# CMC Commercial Unit Five

City of El Paso — City Plan Commission — 03/21/2019

**SUSU19-00010 — Resubdivision Combination**

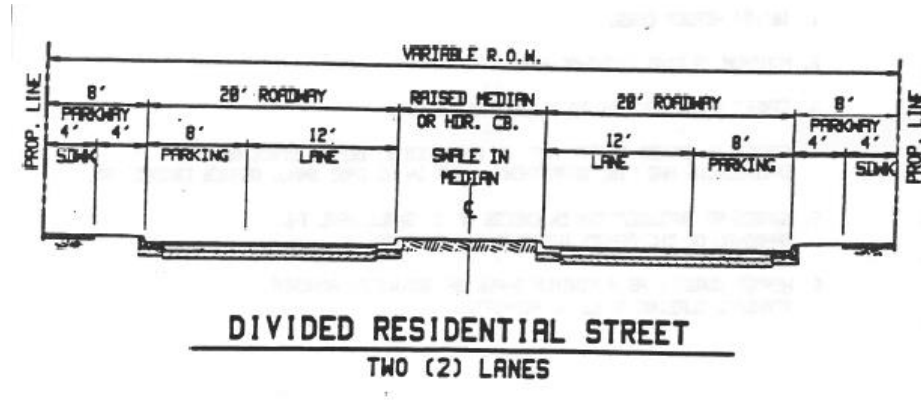
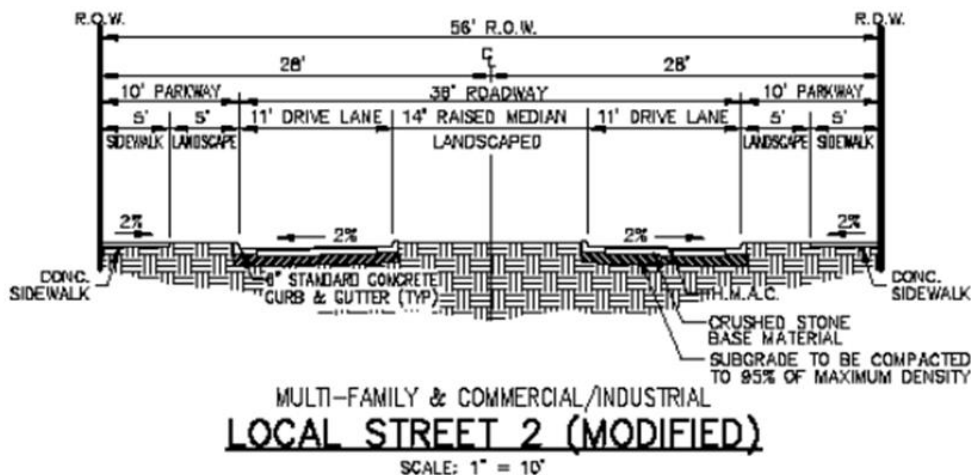
1. To allow a 5' sidewalk and 5' landscape parkway instead of the required 4' sidewalk and 4' landscape parkway.
2. To allow for an 11' driving lane (on opposite directions) instead of the required combined 12' driving lane and 8' parking lane.

Staff recommends **approval** of the modifications pursuant to Section 19.04.170 (Modification of conditions):

A-3. The subdivider has demonstrated an alternative method of development that will improve the aesthetic value of the subdivision while giving equal emphasis to safety, economy, tax yield, maintenance cost, response time, drainage dedication and improvement of parkland and open space amenities, and vehicular access and pedestrian passage.

BEING A REPLAT OF A PORTION OF CMC COMMERCIAL UNIT THREE,  
CITY OF EL PASO, EL PASO COUNTY, TEXAS.  
CONTAINING 20.596 ± ACRES (897,173 SQ. FT.)  
SHEET 1 OF 2

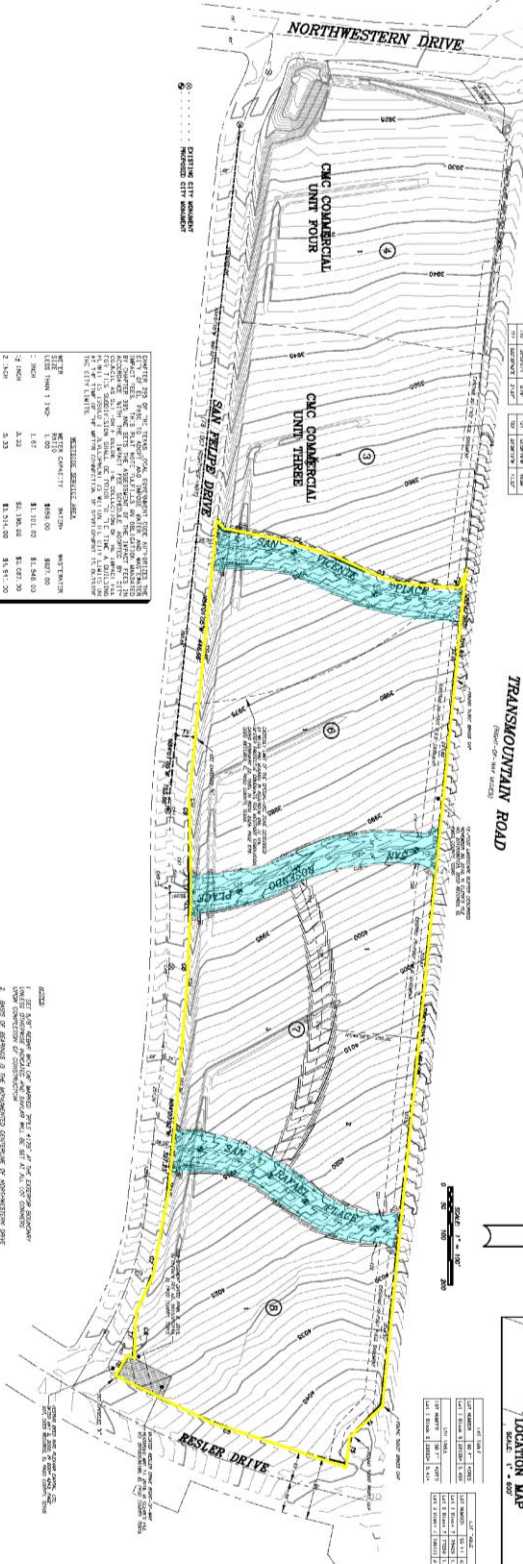
1. Please update the dedication statement to remove the line dedicating the streets to the public.
2. Update the purpose statement for the replat to read "The purpose of this replat is to subdivide a portion of CMC Commercial Unit 3 into 5 lots."

3. If the subdivision is to be identified as a replat of a subdivision and the same subdivision name is to be maintained, the replat shall be labeled consecutively.

4. Include the dimensions and legal description of at least one row of adjacent lots and tracts.
5. Label each segment of the cross section for Loop 375/Transmountain Road.

6. Add flow lines.
7. Add the following addresses onto plats:
  - Lot 1, Block 8- 1990 Transmountain
  - Lot 1, Block 7- 1970 Transmountain
  - Lot 2, Block 7- 1980 Transmountain

- Lot 3, Block 7- 7635 San Felipe
  - Lot 1, Block 6- 7655 San Felipe
8. Remove "Prop" from ROW lines in the Loop 375 cross section.
9. Have the property owner of CMC Commercial Unit Three come in for an address change.

1. Access points match what was previously submitted to TxDOT.
2. Layout need to show Loop 375 off-ramp and distances between access points and between ramp and driveway to east of ramp.
